MILITARY SPECIFICATION

CONNECTORS, PLUG AND RECEPTACLE——ELECTRICAL

This amendment forms a part of Military Specification MIL-C-21617(SHIPS), 23 January 1959.

Figure 14 - Style 004A.

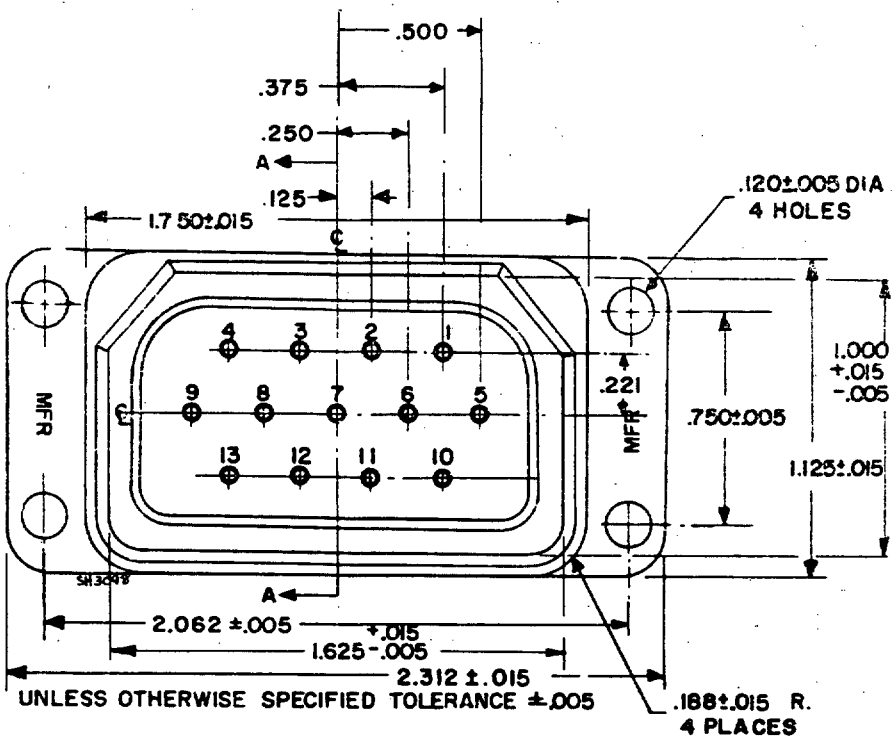
Page 23, figure 14: Delete and substitute:

Service rating A
2 size 4 contacts
2 size 8 contacts

Figure 16 - Style 013A.

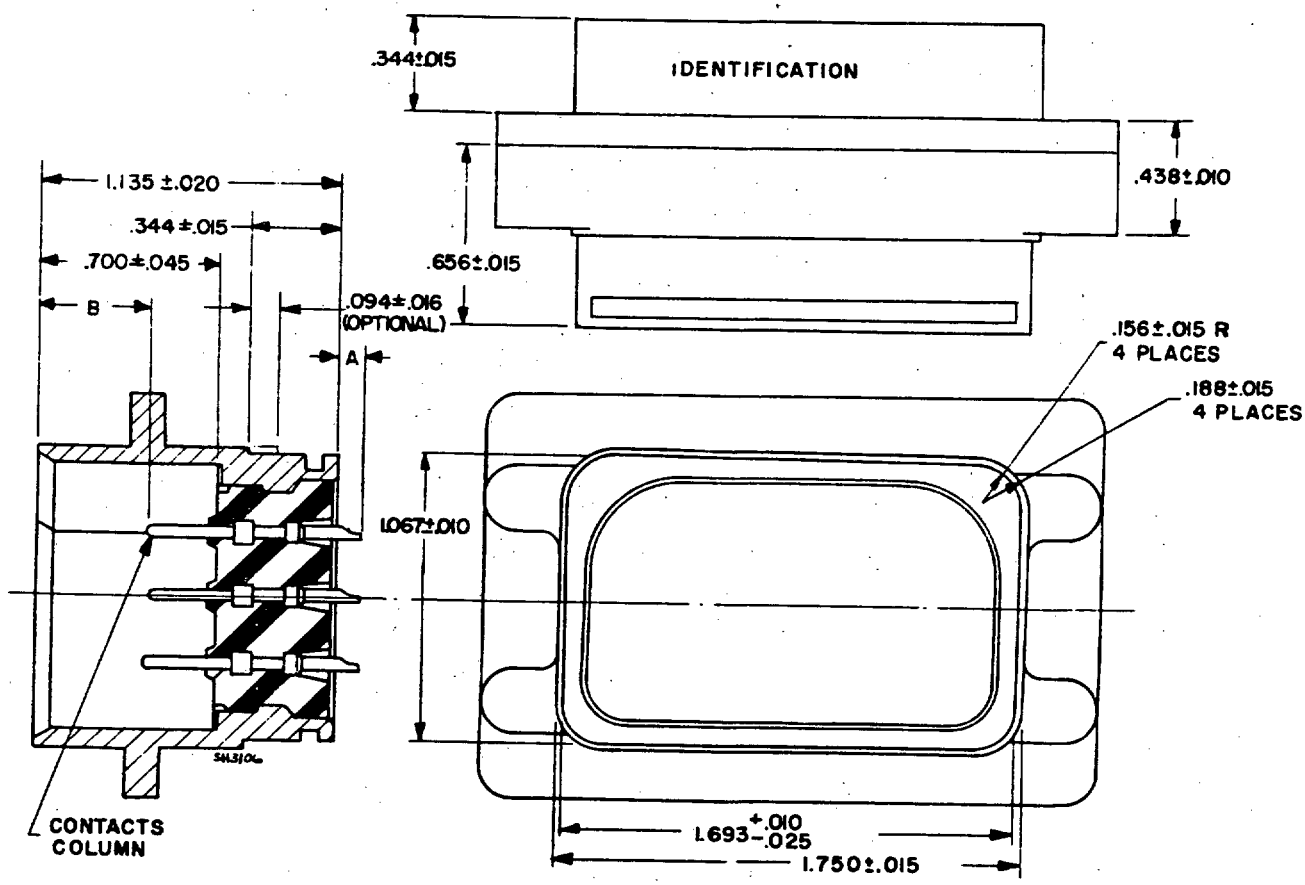
Page 25, figure 16: Delete and substitute:

Service rating D
13 size 16 contacts

Figure 24 - Type JS, class M.

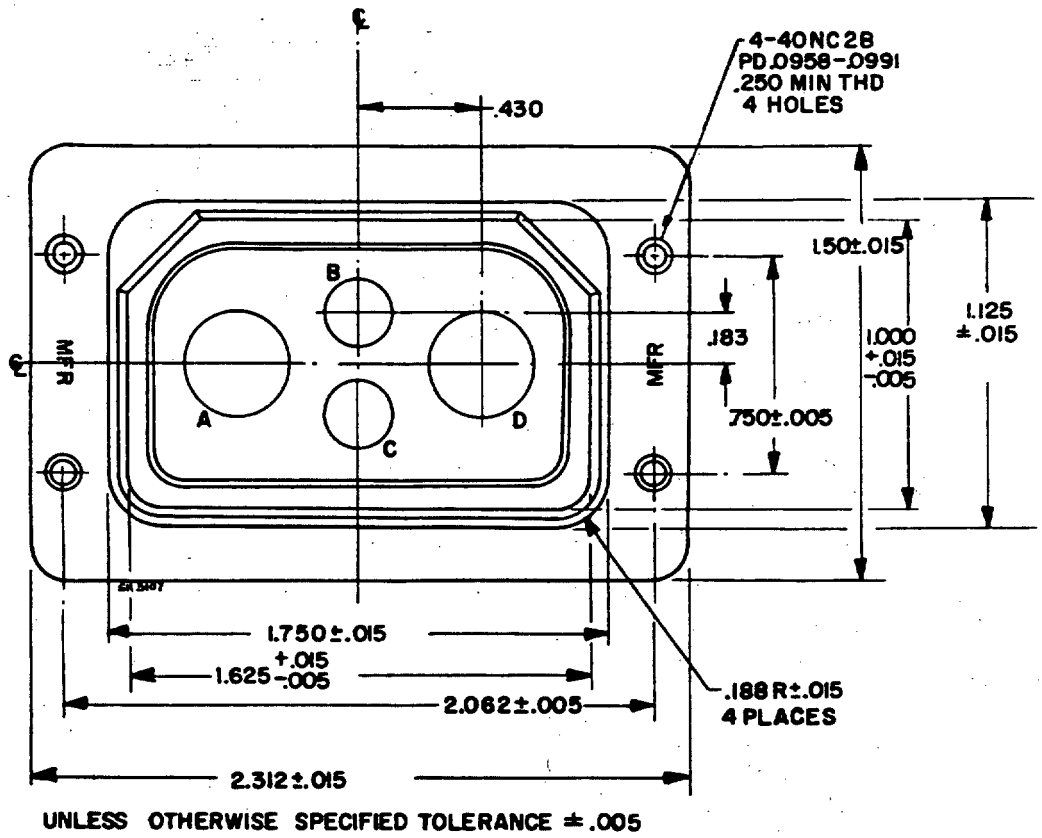
Pages 34 through 42, figures 24 through 32: Delete and substitute:

CONTACT SIZE	20	16	8	4
"A" DIMENSION	0.052 ±.045	0.156±.045	0.312 ±.045	0.312 ±.045
